**NOTICE  
OSHTEMO CHARTER TOWNSHIP  
Zoning Board of Appeals**

**Tuesday,  
July 26, 2016  
3:00 p.m.**

**AGENDA**

1. Call to Order
2. Pledge of Allegiance
3. Public Comment on Non-Agenda Items
4. Approval of Minutes: June 28, 2016
5. **Site Plan Review (One Way Products, 6101 West KL Avenue)**  
Applicant, Glas Associates, is requesting site plan review for a new manufacturing facility for One Way Products at 6101 West KL Avenue. Parcel No. 3905-24-305-010.

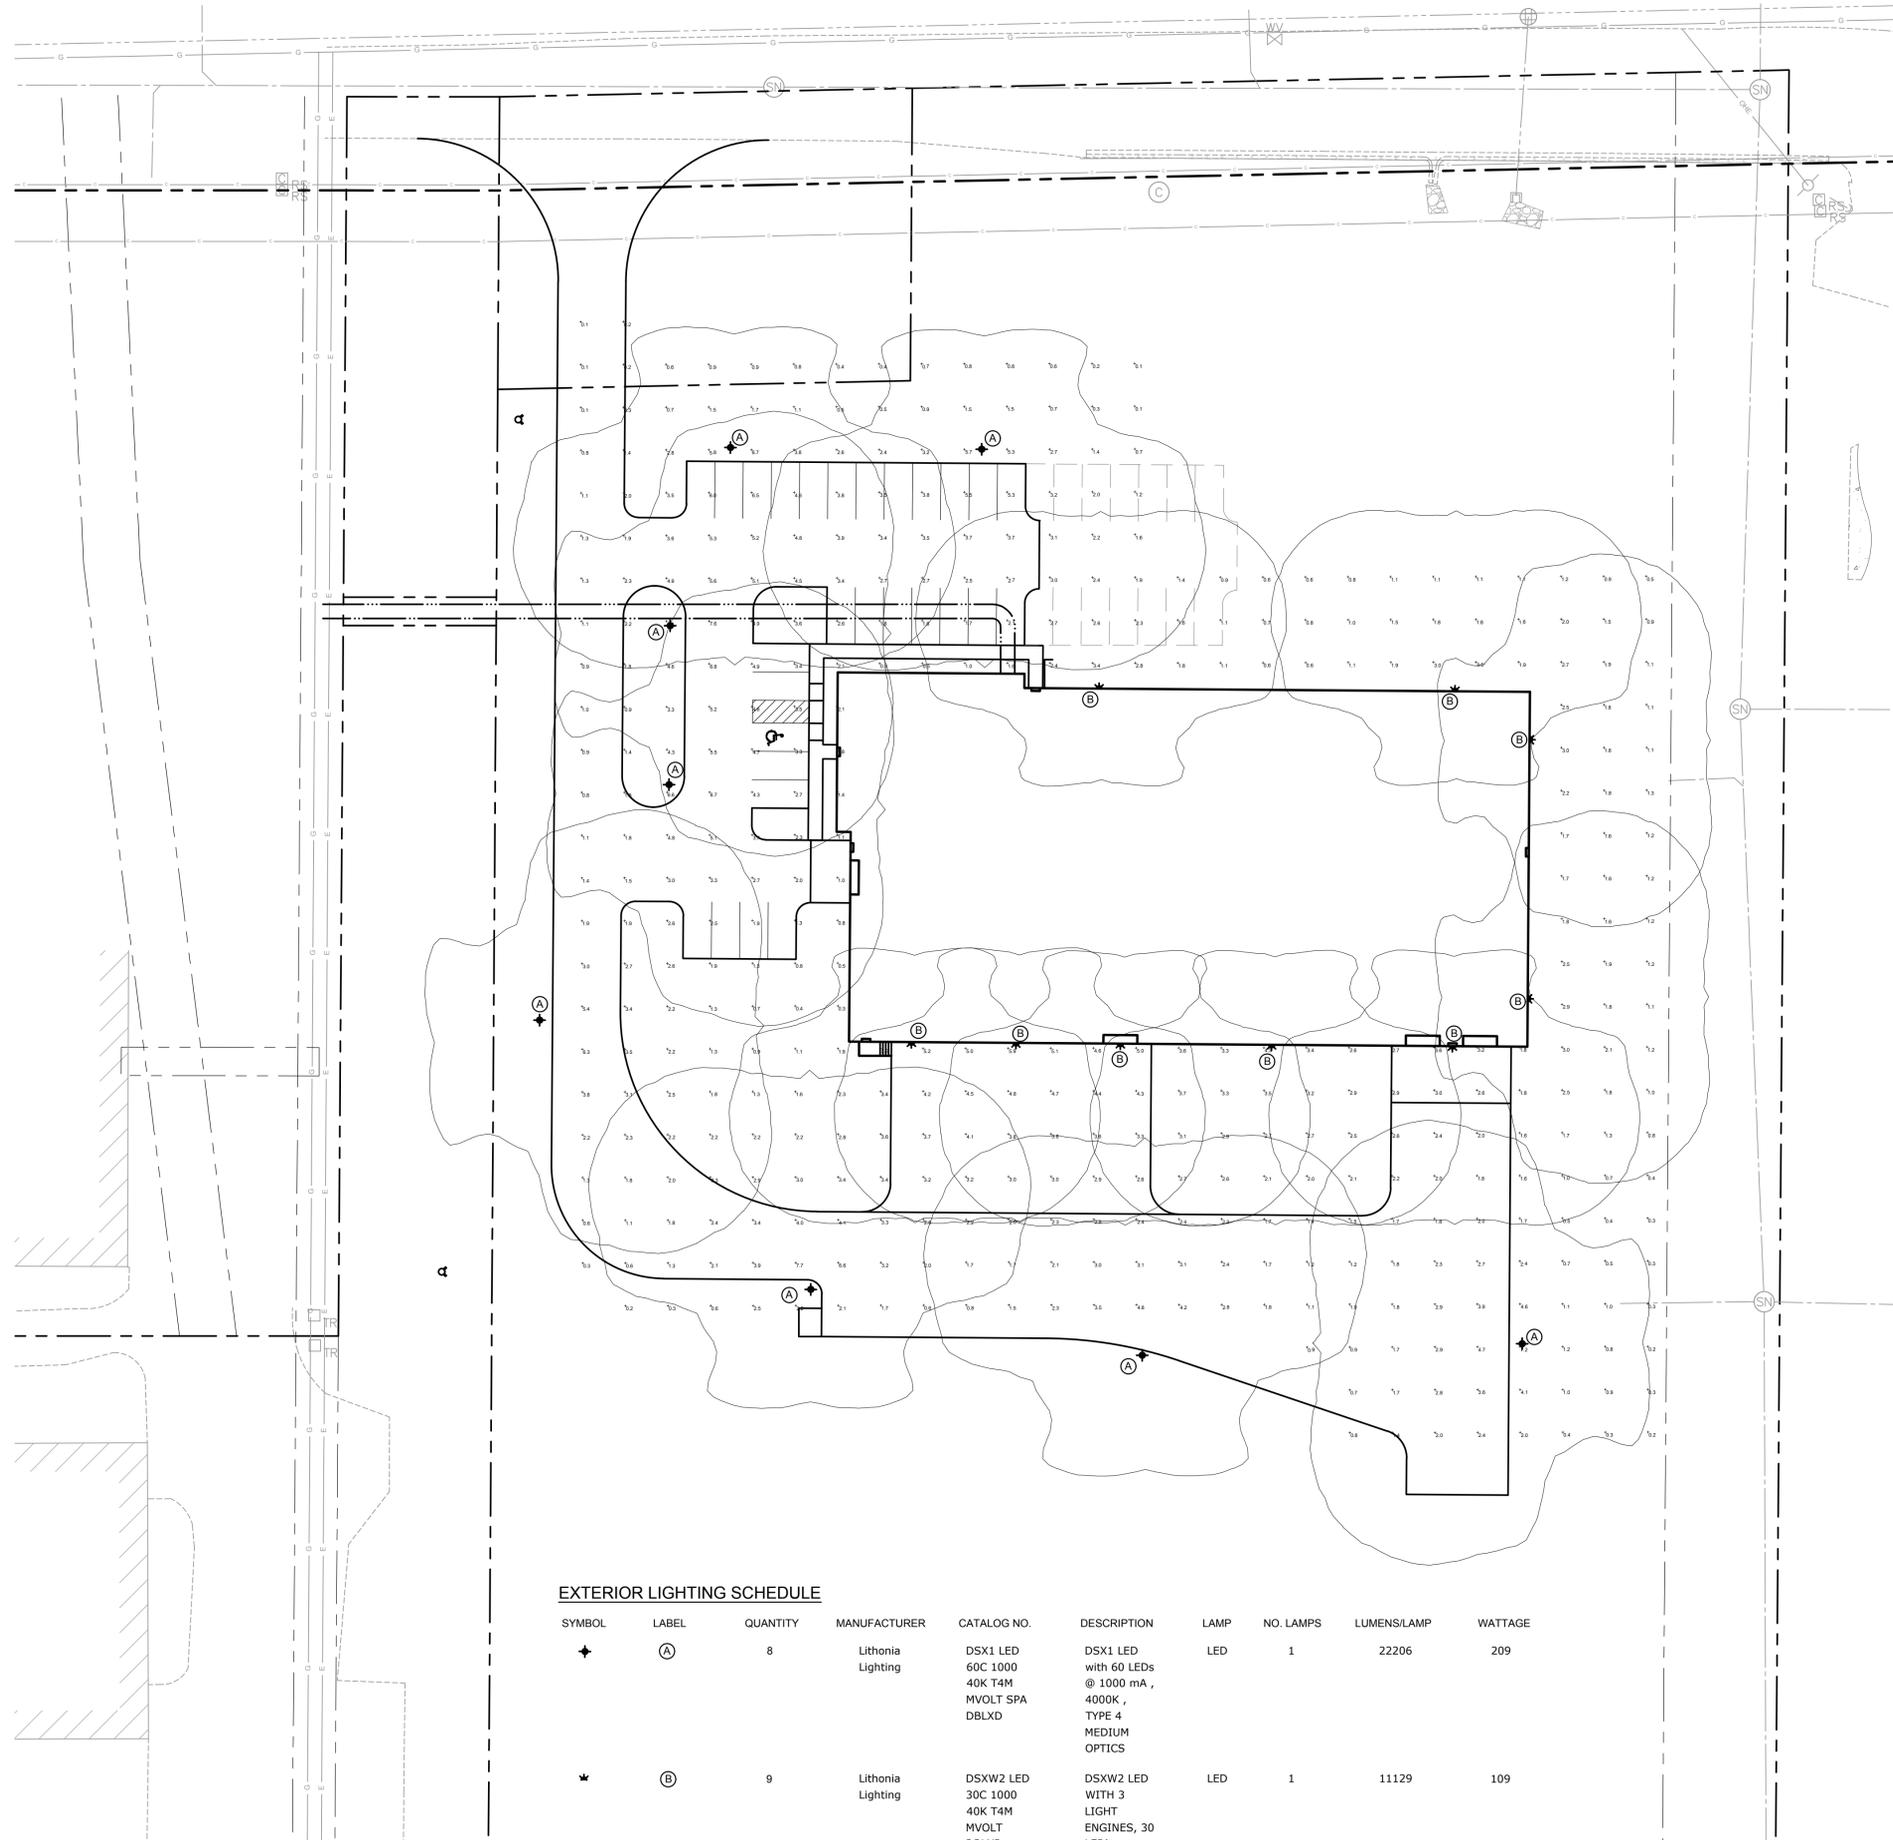
The photometric plan is required to show 0.1 foot candles at the property line or, at a minimum, that 0.1 foot candles is accomplished before reaching the property line. The current plan does not provide this information.

1. A revised site plan be submitted that meets all Fire Marshal and Township Engineer requirements.
2. A revised photometric plan showing the required 0.1 foot candles at the property boundary.
3. Prior to the Certificate of Occupancy, a staff review of landscaping will occur. If landscaping materials are lost during construction to the point of noncompliance with the Zoning Ordinance, additional landscape materials will be required.
